PROJECT : HOUSE DANCASTER
 DEVIATIONS TO APPROVED PLANS
 NO. 223/03/08 ON PTN 2 OF 1580
 NO. 7 WESTMINSTER PLACE,
 DURBAN NORTH

DRAWING STAGE : DEVIATIONS RATE VOLUME No. :
 DRAWING TITLE : SITE GROUND FLOOR PLAN

DRAWING NUMBER : S/601/05/01 REVISION NO. 1

SITE PLAN & GROUND STORY PLAN

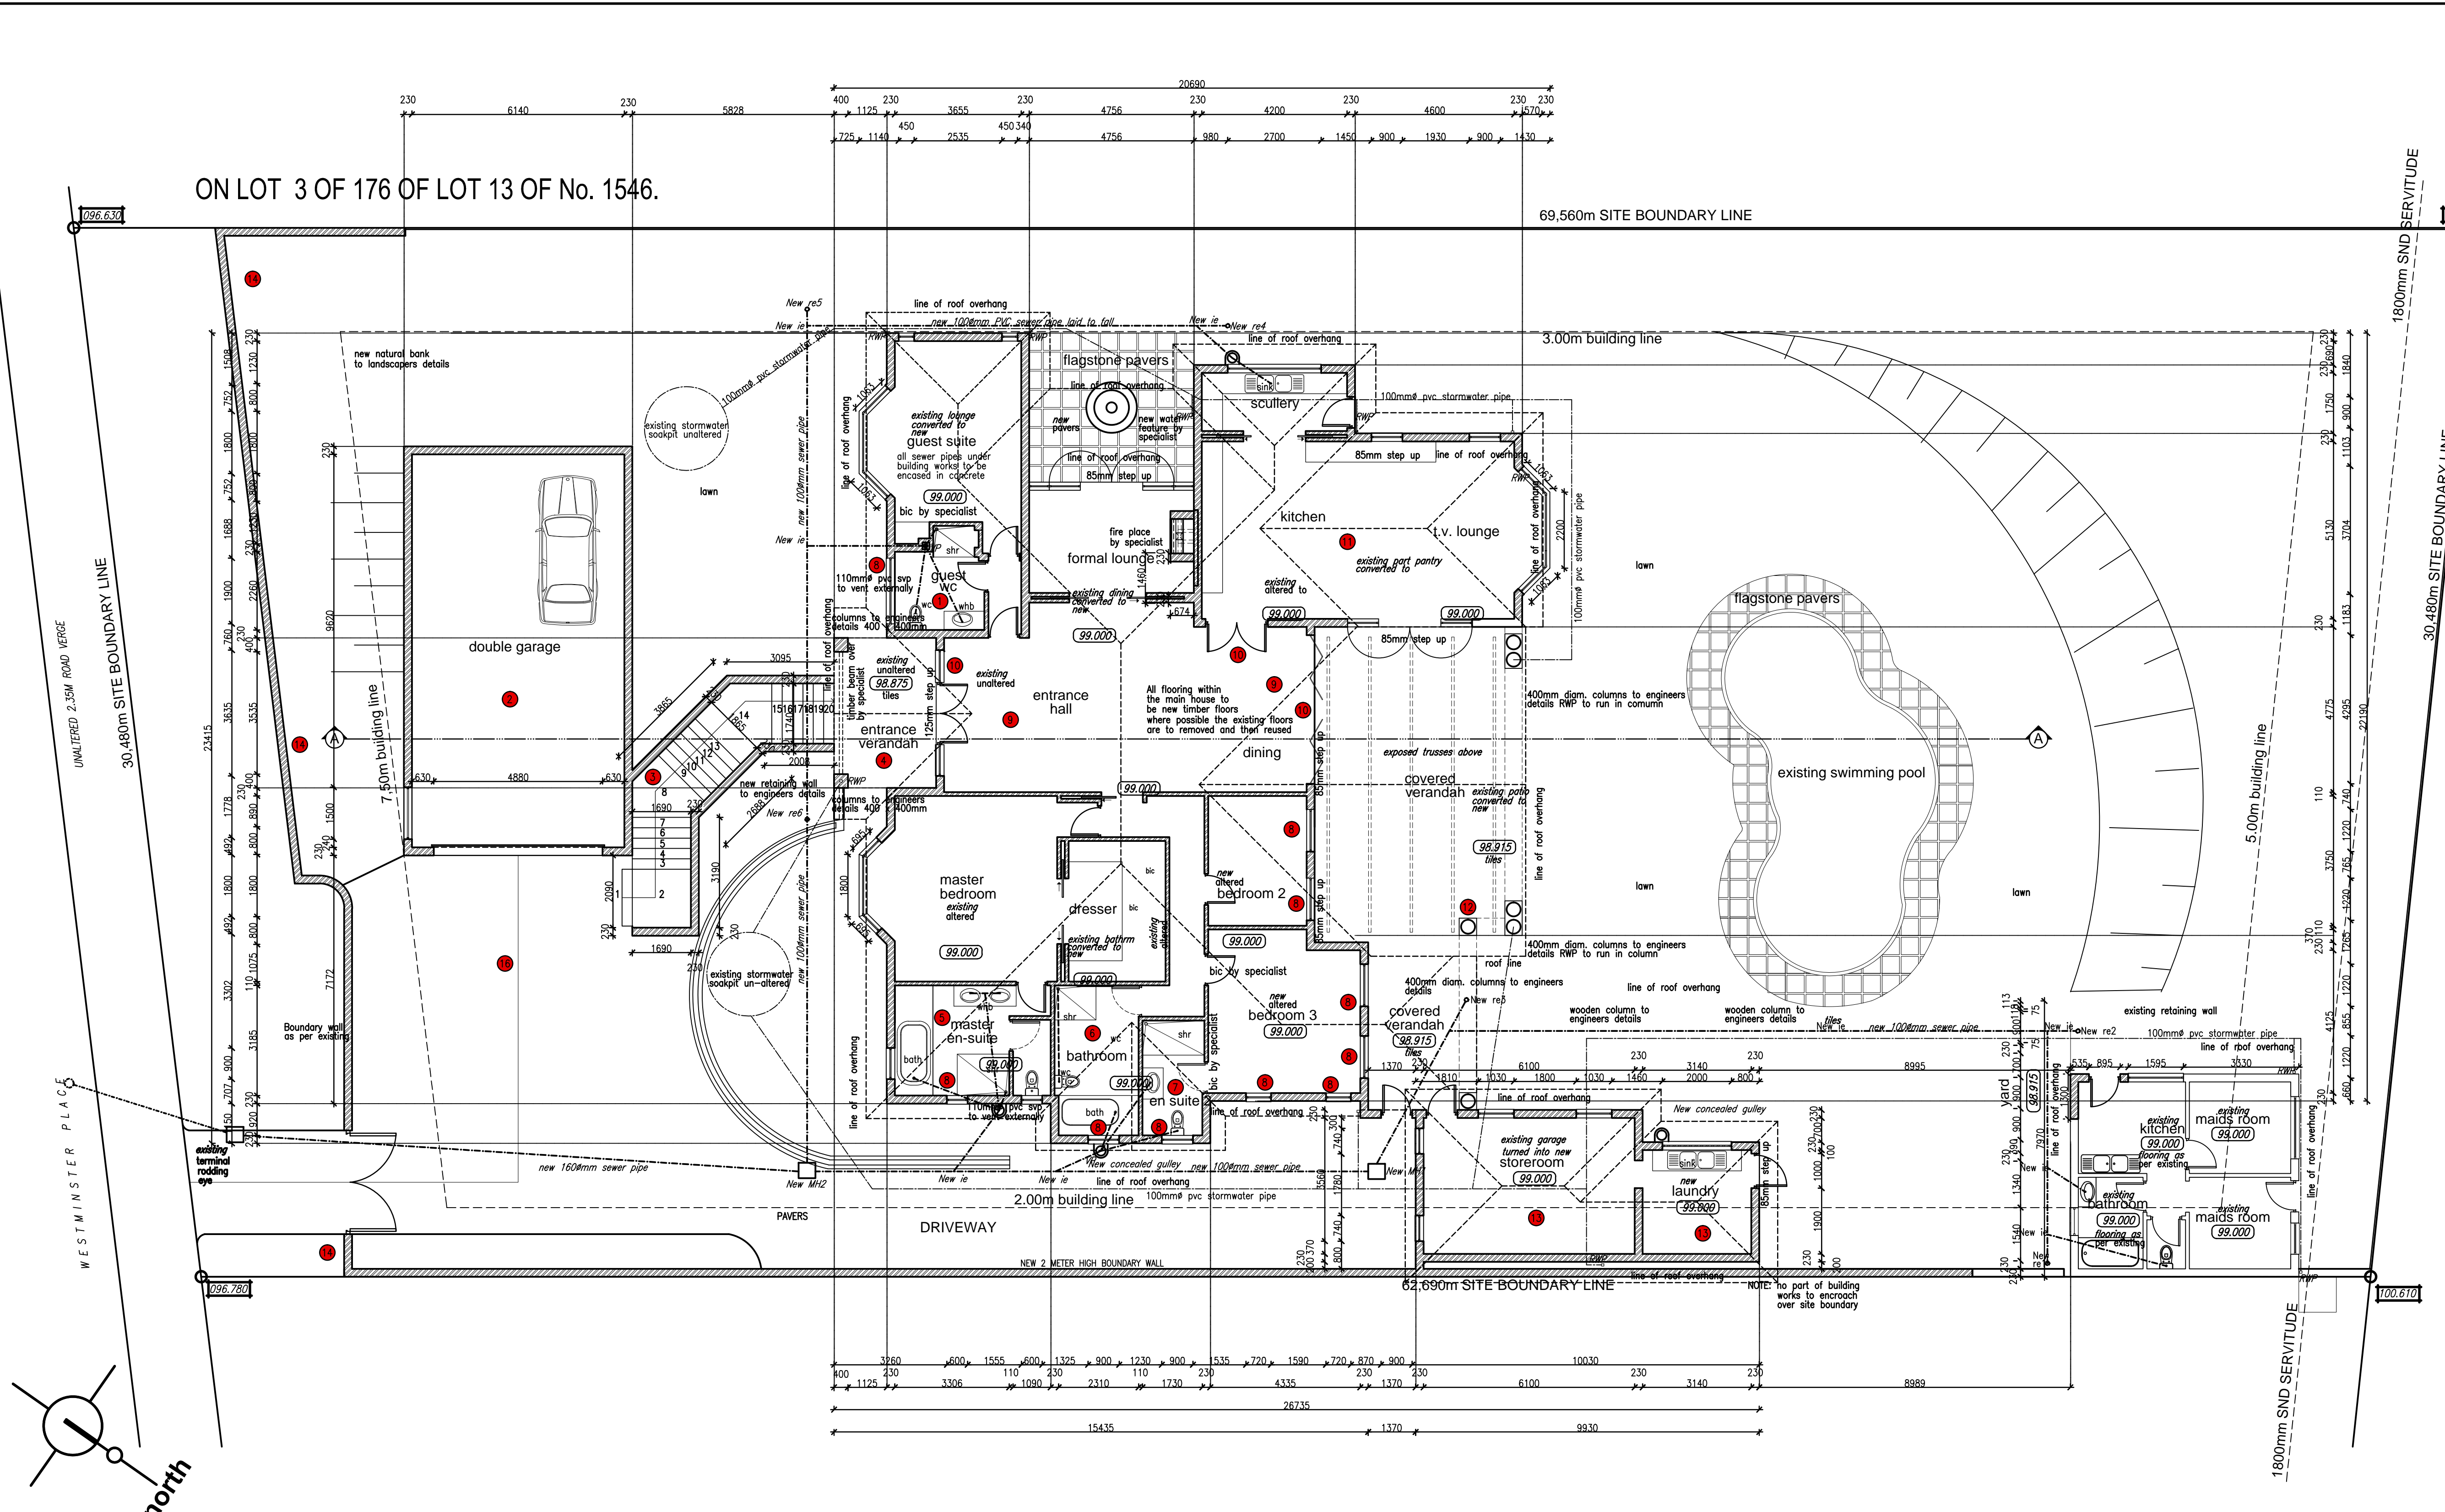
LIST OF DEVIATIONS

- DESIGN TO GUEST W/C AMENDED
- DOUBLE GARAGE REPOSITIONED AND REDESIGNED
- NEW STAIRCASE TO ENTRANCE
- ENTRANCE VERANDAH REDESIGNED
- MASTER EN-SUITE REDESIGNED
- BATHROOM REDESIGNED
- EN SUITE 2 ADDED
- ENTRANCE HALL REDESIGNED
- NEW DOOR
- KITCHEN REDESIGNED
- COLUMN ADDED
- EXISTING GARAGE TURNED INTO NEW STOREROOM, LAUNDRY
- FRONT BOUNDARY WALL REDESIGNED
- ROOF LAYOUT AMENDED ACCORDINGLY
- DRIVEWAY LAYOUT AMENDED ACCORDINGLY
